Permit Number: 080005

AT 43-45 TURNER ST

# City of Portland, Maine - Building or Use Permit Application

RE: 43-45 Turner Street  
CBL: 014-H-015  
Application ID: 2007-0212

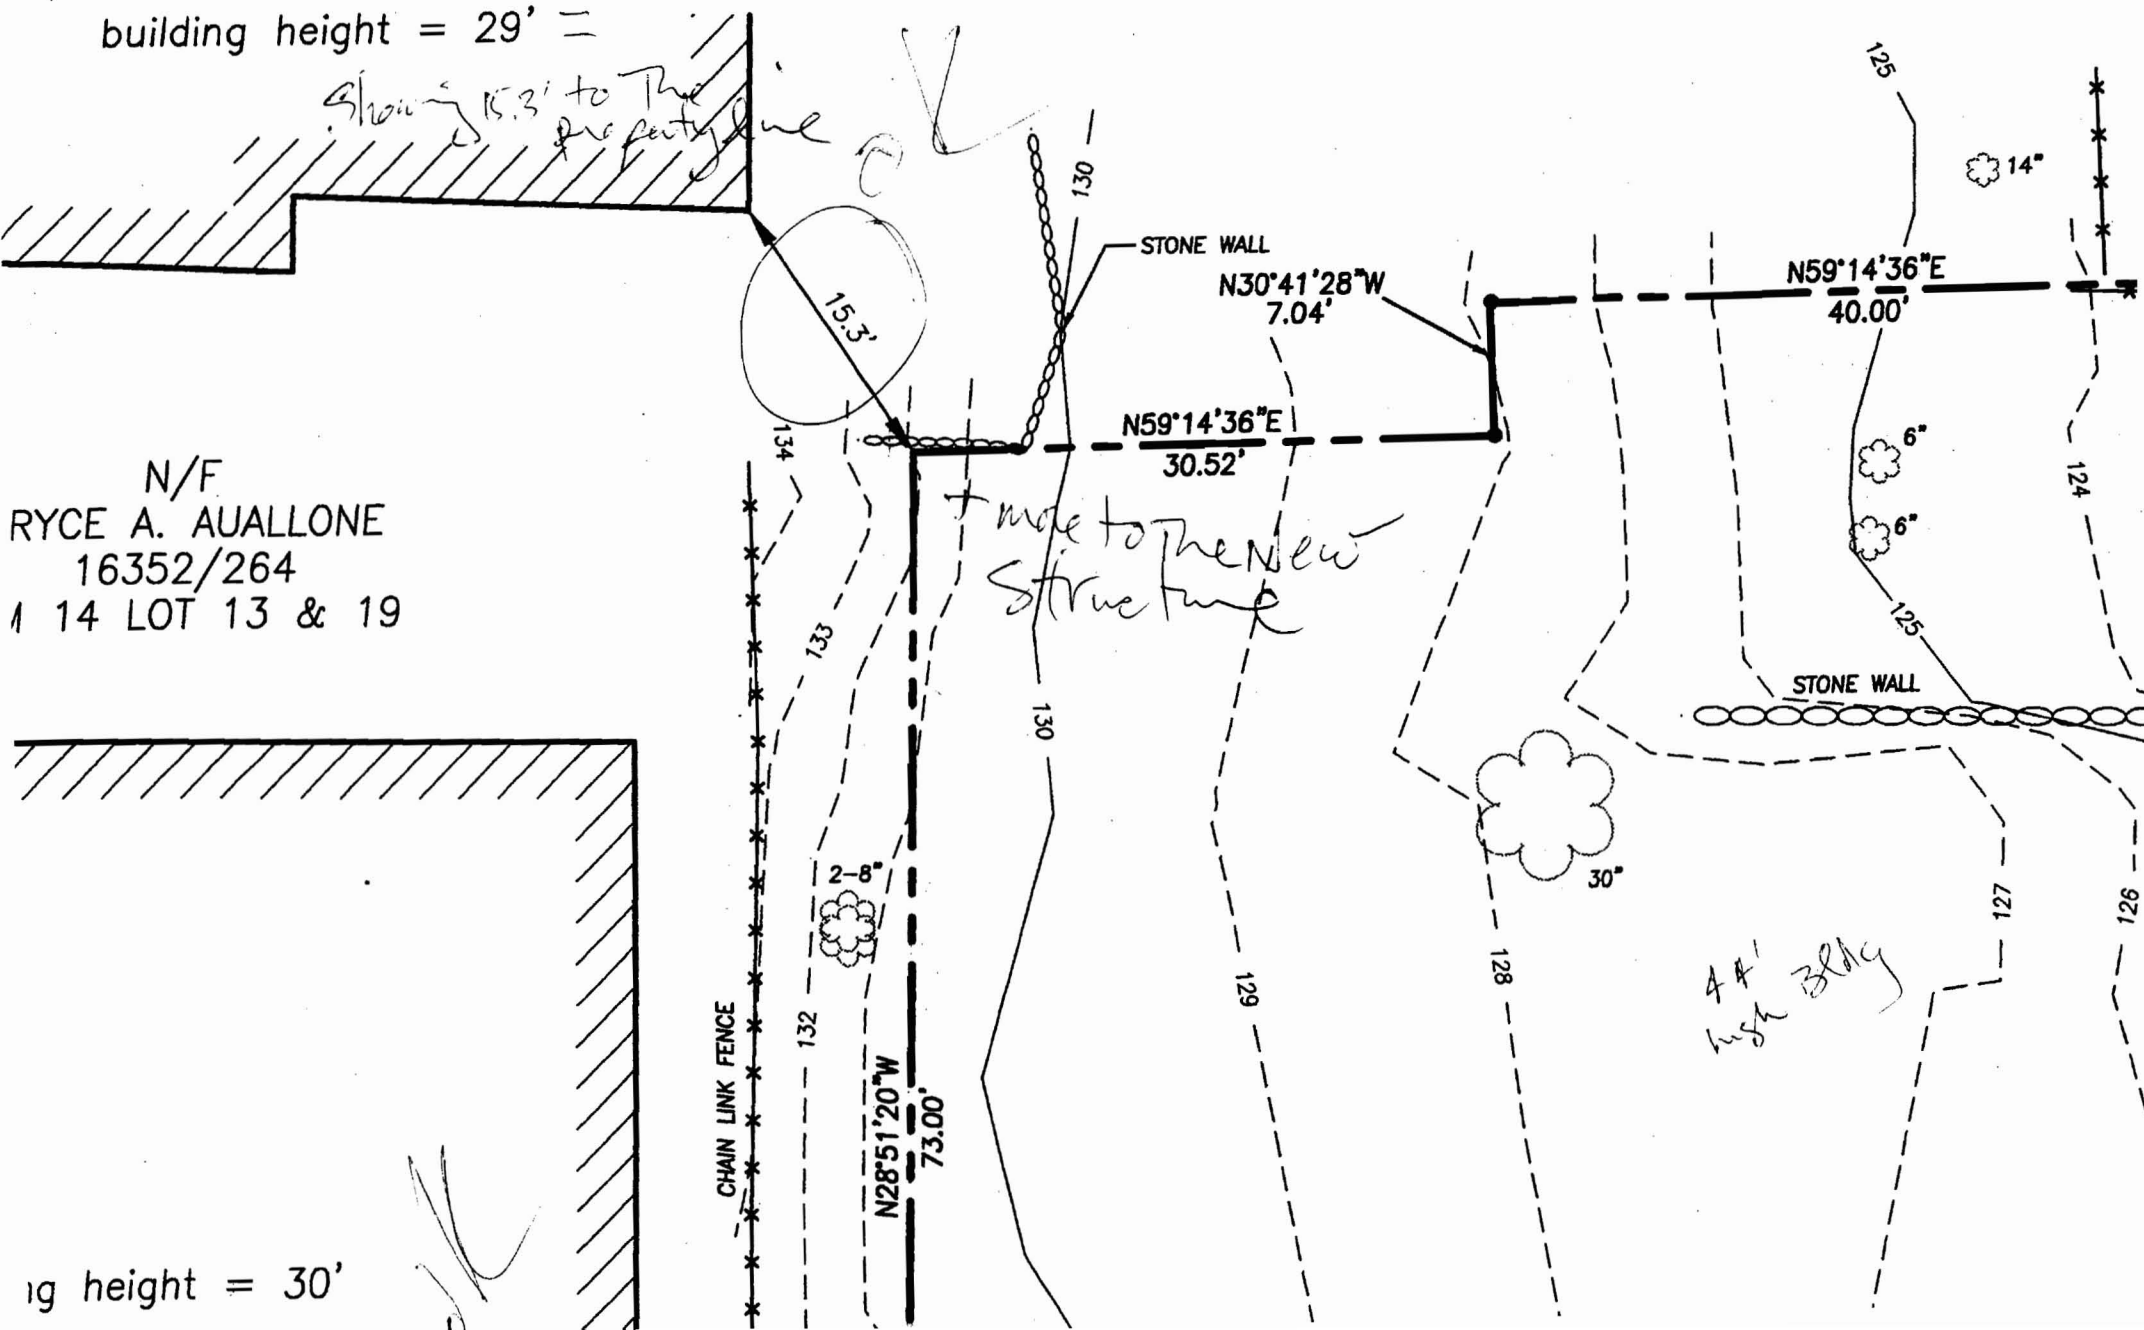
ABUTTING HOUSE HEIGHT	29'
ABUTTING HOUSE SIDE YARD	15.3'
PROPOSED BUILDING HEIGHT	44'
PROPOSED SIDE YARD	12'
COMBINED BUILDING HEIGHT	73'
MINIMUM SEPARATION	14.6'
(COMBINED HEIGHT / 5)

Showing 15.3' to the property line
